Moultonborough Grange Hall

Building Condition Assessment

**Re: Moultonborough Grange Hall, Moultonborough, NH
HEB Project #2012-102**

H.E. Bergeron Engineers, Inc. (HEB) has prepared the following structural review of the rafter beam repair at the Moultonborough Grange Hall. We visited the site with you on November 16, 2012 and received your proposed repair sketches via email on November 26, 2012. This work was conducted in accordance with our Letter Agreement, dated November 14, 2012.

TYPICAL CONNECTIONS (NO POST)

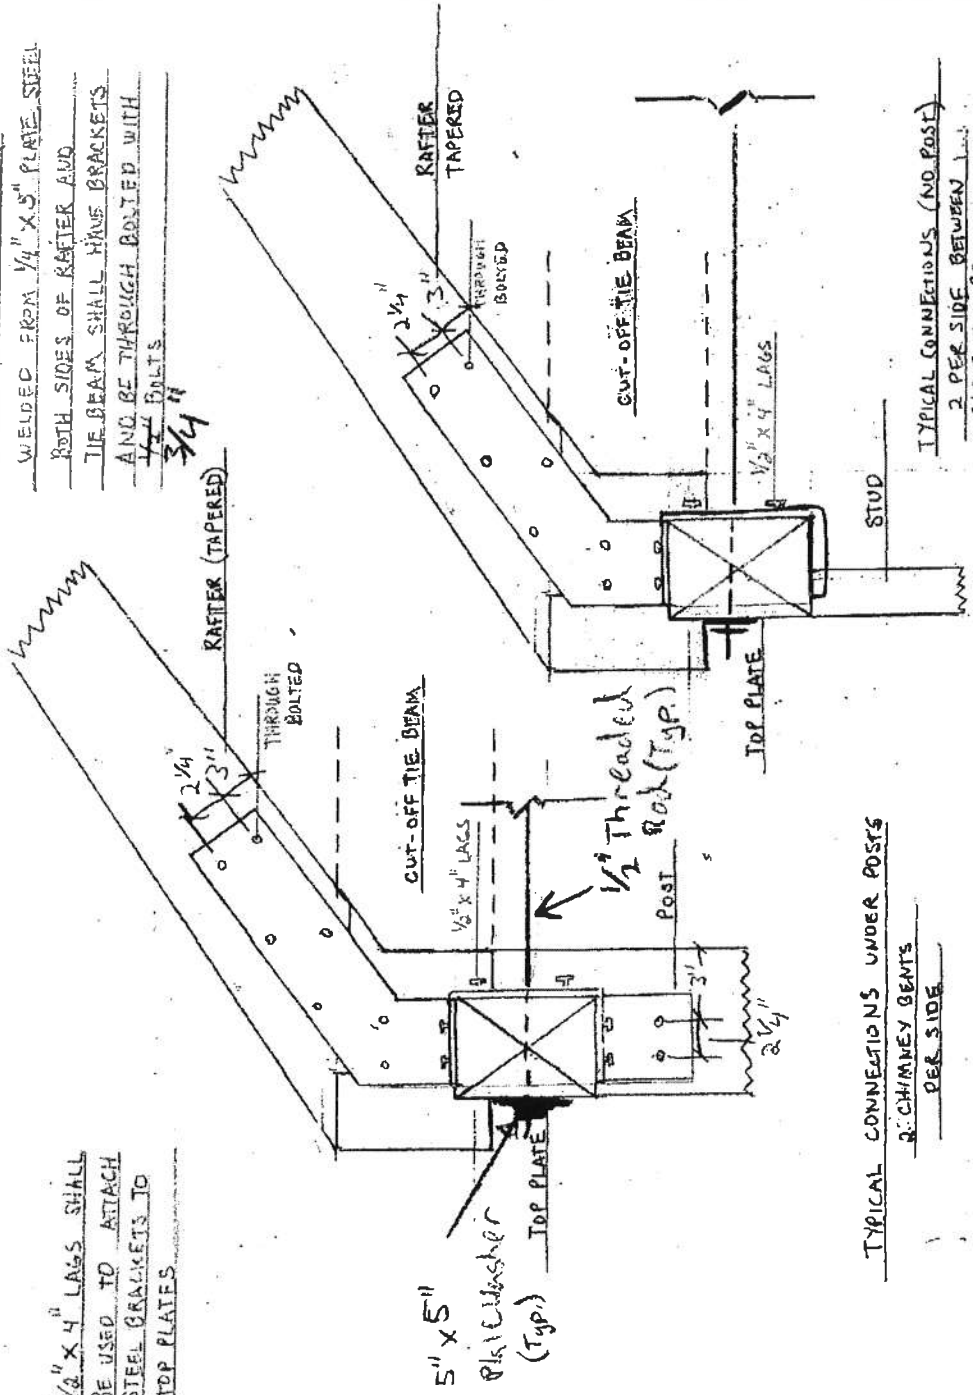
The sketches you provided are generally acceptable as a repair to the cut off tie-beam with the following exceptions/requirements:

- All bolts shall be $\frac{3}{4}$ ".
- Bolts shall be installed in two rows with a minimum center of bolts spacing of 2.25" between bolts, 3" from the inside rafter/post edge, and 1.25" from the outside rafter/post edge.
- Tie-beam shall be $\frac{1}{2}$ " min. steel rod.
- Tie-rod plate washer shall be 5"x5"x $\frac{1}{4}$ " min.

See the attached marked up sketches and note sheet for structural and structural steel requirements.

provided by Steve Beland
1/2" x 4" LAGS SHALL
BE USED TO ATTACH
STEEL BRACKETS TO
TOP PLATES

STEEL BRACKETS CUSTOM

WELDED FROM 1/4" x 5" PLATE STEEL

BOTH SIDES OF RAFTER AND

TIE BEAM SHALL HAVE BRACKETS

AND BE THROUGH BOLTED WITH

1/2" BOLTS

3/4"
